ALAMEDA COUNTY COMMUNITY DEVELOPMENT AGENCY  
PLANNING DEPARTMENT

STAFF REPORT

**APPLICATION:** PLN2021-00044

**PROPOSAL:** **MODIFICATIONS TO PREVIOUS APPROVAL FOR VESTING TENTATIVE TRACT MAP SUBDIVISION (TR-8607) AND SITE DEVELOPMENT REVIEW**, to allow revision to a new mixed-use multi-family project with 138 (previously 163) rental housing units, 11,049 (previously 11,524) sq. ft. of indoor retail, 983 (previously 660) sq. ft. of outdoor retail seating area, no proposed realignment of Via Mercado.

Revisions		No.	Date
Scale	AS SHOWN	06/03/2021	
Design	AP, AR		
Drawn	AP, AR		
Approved	KW		
Job No	20171017		
Drawing Number:			
C5.1			
9 OF 11

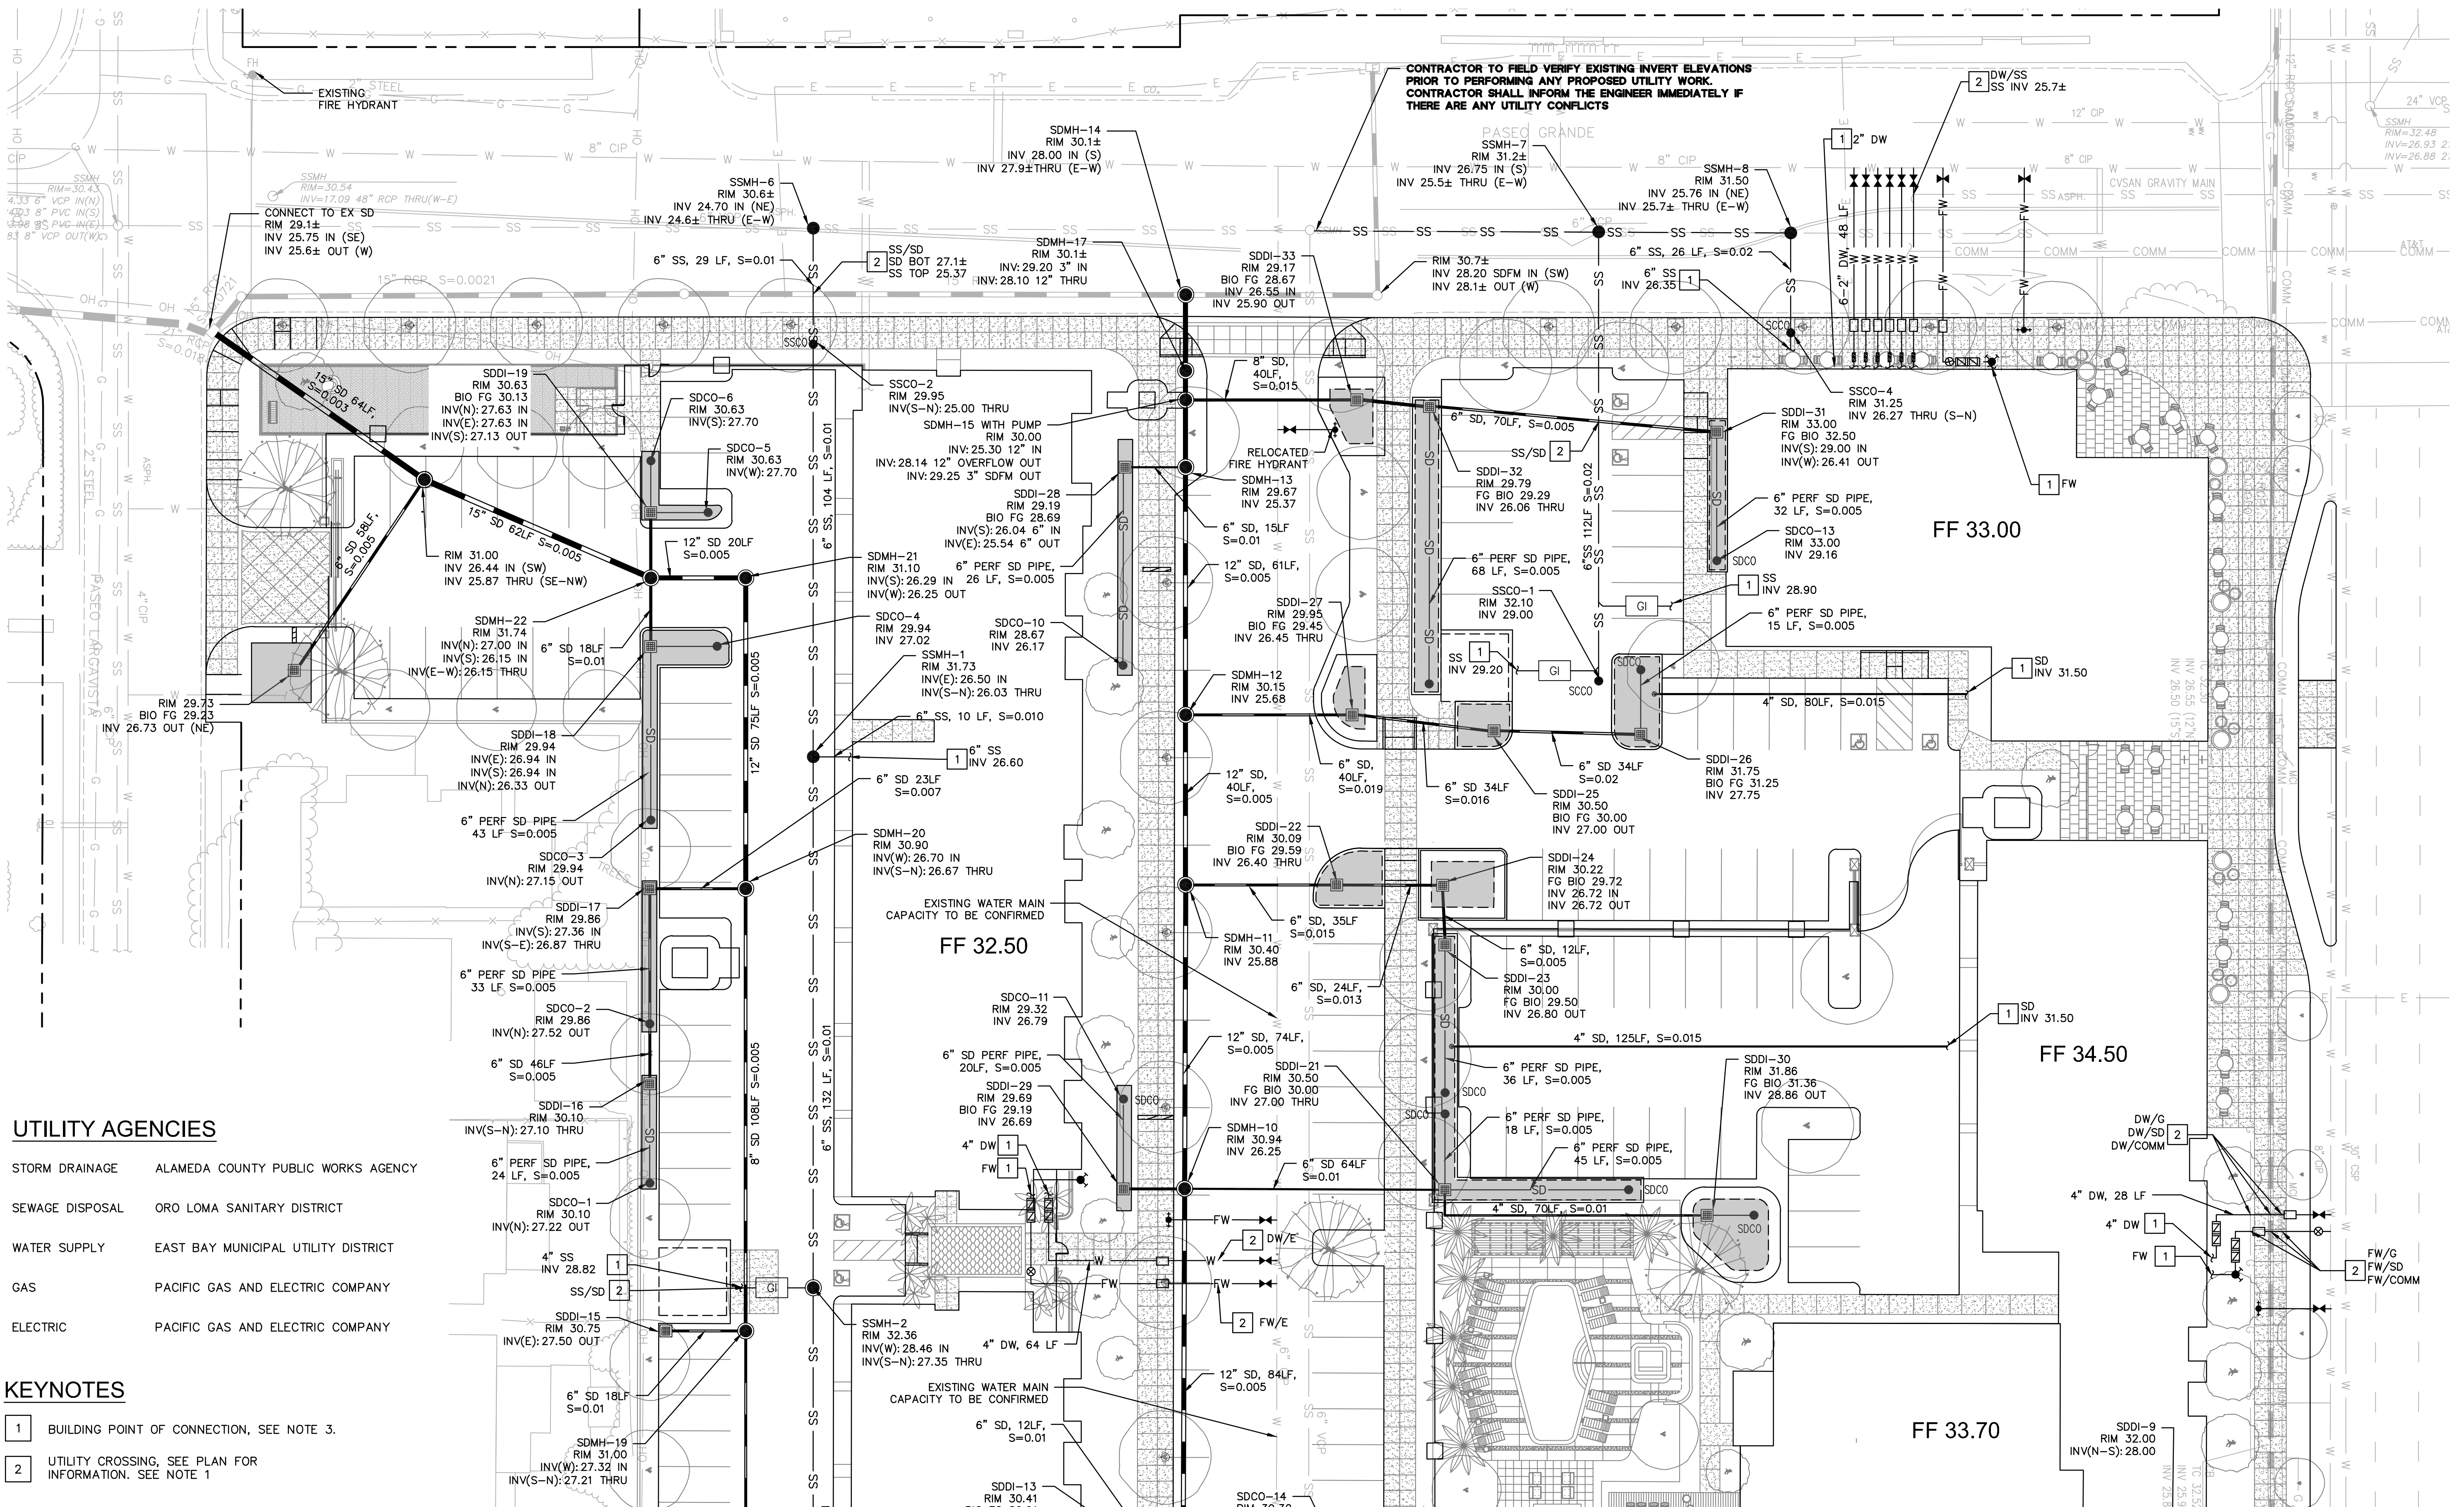
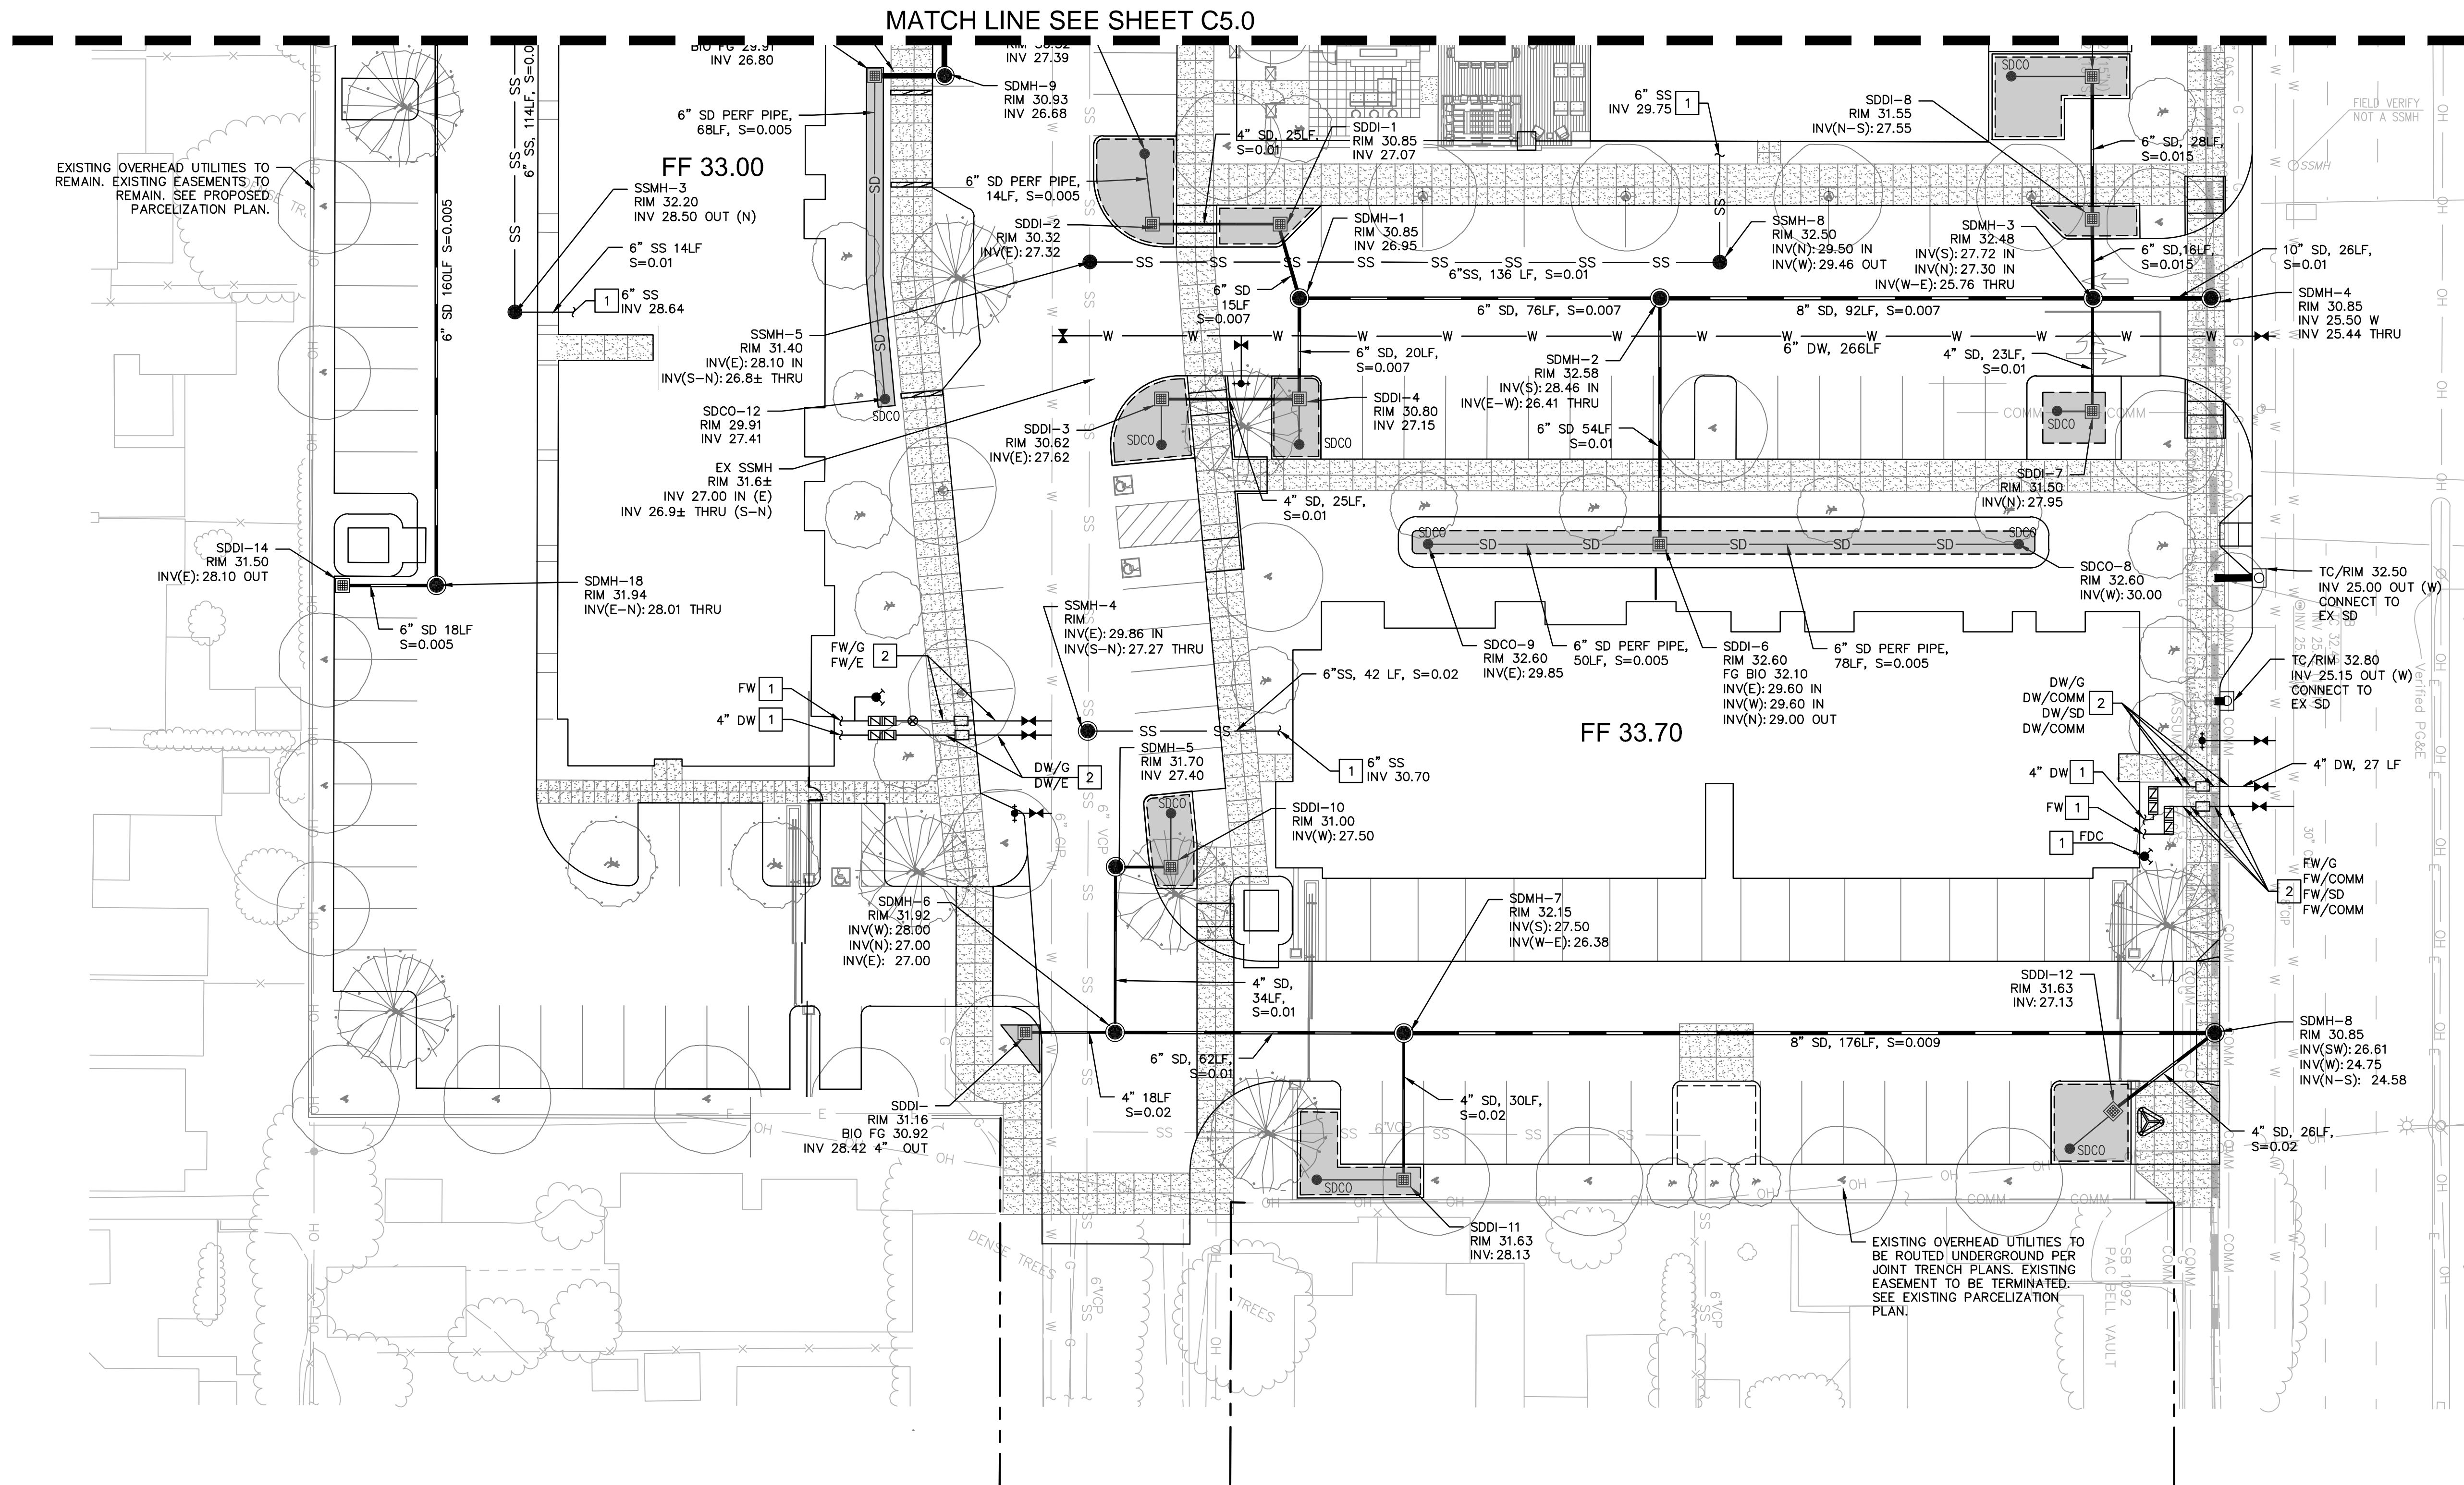
8	Underground the existing overhead utilities along the southerly property line, between Hesperian Boulevard and Via Arriba.	The proposed utility plan C4.1 notes the new underground routing of the existing overhead utilities on the southern property line. The design and alignment of the underground routing will be provided by the joint trench consultant during permitting. Power transformers have been located per Planning request.
9	All on-site and on-street parking stalls shall have sufficient access and maneuvering area. Developer shall prepare and submit turn and tire sweep diagrams.	The site plan and parking layout meets or exceeds County standards. Developer and design team agree to work with Building and PWA during permitting to address any specific concerns.
10	Ensure that curb ramps are provided for all disabled parking spaces.	All accessible parking stalls have curb ramps.
11	Parking is not allowed to overhang sidewalk. However, it can overhang into a landscape planter.	All parking stall adjacent to sidewalks will have wheel stops to prevent overhang or landscape strips will be provided to meet this condition.
